**PCN# 20070809002**  
**Ceramic Hermetic Flipchip seal process change**  
**Final Change Notification / Sample Request**

<b>PCN Number:</b>	20070809002	<b>PCN Date:</b>	08/17/2007
<b>Title:</b>	Ceramic Hermetic Flipchip seal process change		
<b>Customer Contact:</b>	<a href="#">PCN Manager</a>	<b>Phone:</b>	(214) 480-6037
		<b>Dept:</b>	Quality Services
<b>Proposed 1<sup>st</sup> Ship Date:</b>	11/17/2007	<b>Estimated Sample Availability:</b>	10/31/2007
<b>Change Type:</b>			
<input type="checkbox"/>	Assembly Site	<input checked="" type="checkbox"/>	Assembly Process
<input type="checkbox"/>	Design	<input type="checkbox"/>	Electrical Specification
<input type="checkbox"/>	Test Site	<input type="checkbox"/>	Packing/Shipping/Labeling
<input type="checkbox"/>	Wafer Bump Site	<input type="checkbox"/>	Wafer Bump Material
<input type="checkbox"/>	Wafer Fab Site	<input type="checkbox"/>	Wafer Fab Materials
<input type="checkbox"/>		<input type="checkbox"/>	Assembly Materials
<input type="checkbox"/>		<input type="checkbox"/>	Mechanical Specification

#### Description of Change:

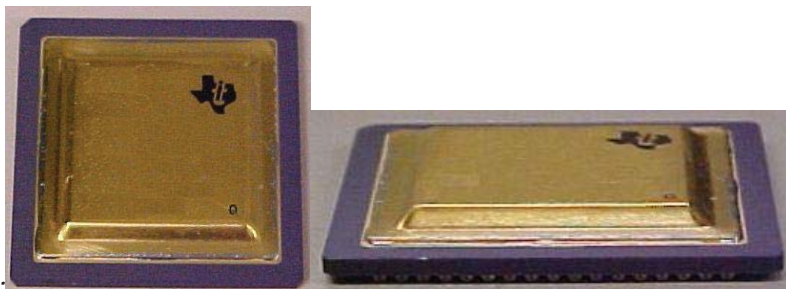
Changing from a AuSn solder seal process to a parallel seam seal welding process.

*Change From:*

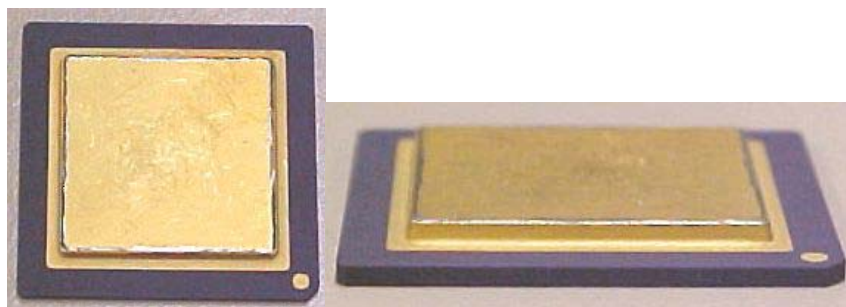
Form: visual appearance changes slightly. The old version has a top-hat lid that has sloped lid design whereas the new version lid is perpendicular to the substrate in design.
